Project	IEEE 802.16 Broadband Wireless Access Working Group < http://ieee802.org/16 >	
Title	ACS procedure in Coexistence Community	
Date Submitted	2005-11-08	
Source(s)	Pan Zhong Huawei Huawei Industrial Base, Bantian, Longgang, Shenzhen 518129 P.R.C	Voice: +86-755-28971675 Fax: +86-755-28972149 panz@huawei.com
Re:	80216h-05_023: Call for Contributions IEEE 802.16's License-Exempt (LE) Task Group. 2005-10-17	
Abstract	Clarify the concept of community and proposed a efficient method for coexistence ACS	
Purpose		
Notice	This document has been prepared to assist IEEE 802.16. It is offered as a basis for discussion and is not binding on the contributing individual(s) or organization(s). The material in this document is subject to change in form and content after further study. The contributor(s) reserve(s) the right to add, amend or withdraw material contained herein.	
Release	The contributor grants a free, irrevocable license to the IEEE to incorporate material contained in this contribution, and any modifications thereof, in the creation of an IEEE Standards publication; to copyright in the IEEE's name any IEEE Standards publication even though it may include portions of this contr

Figure h29 Process of ACS

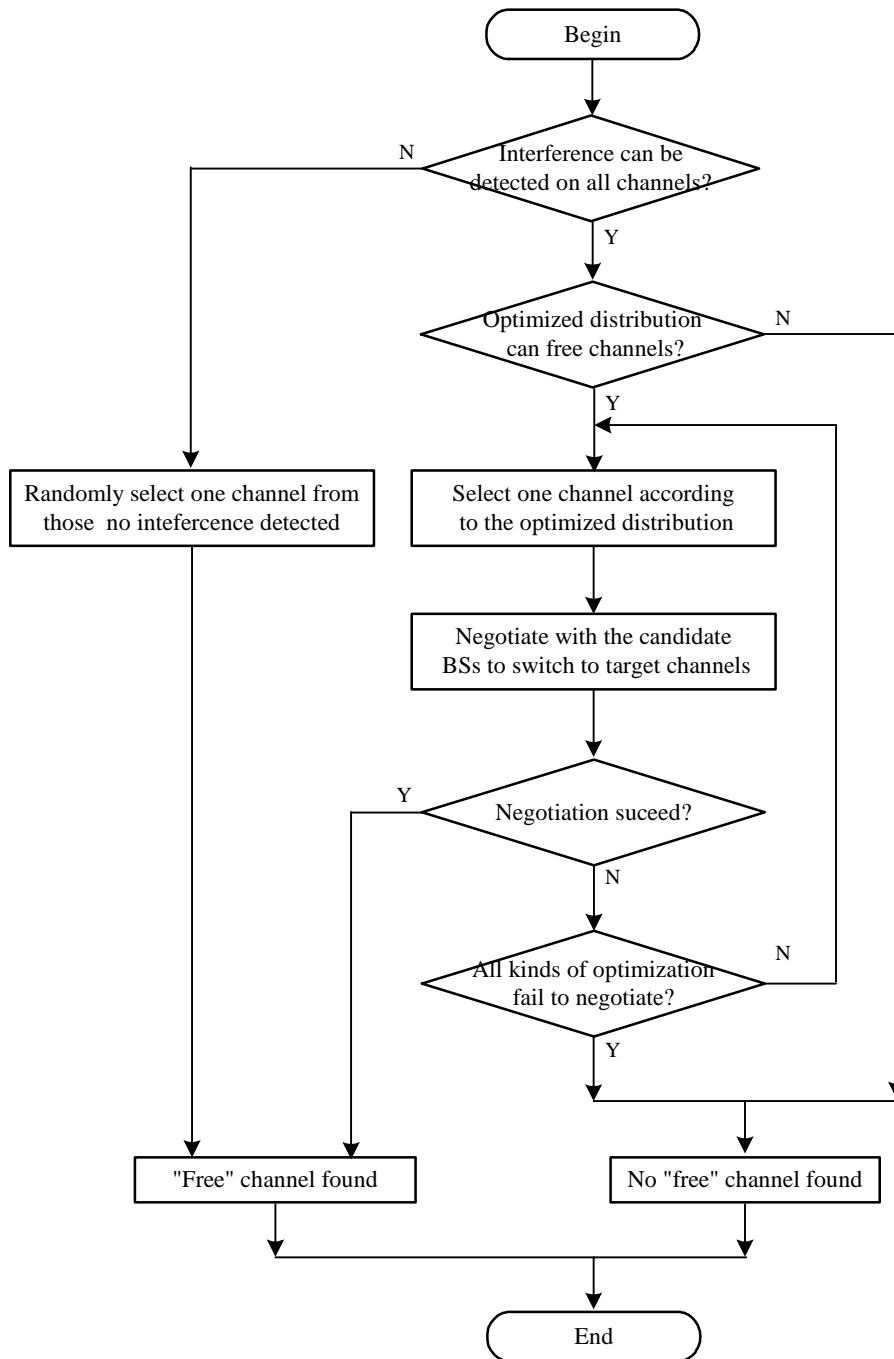
Process of ACS is shown in Figure h29. ACS results two kinds of resolution, a "free" channel found with or without channel switching, or no "free" channel found.

If a “free” channel found, means default interference-free Master slot is available, otherwise, IBS need to share the channel with coexistence neighbors, as described in 15.2.1.7.
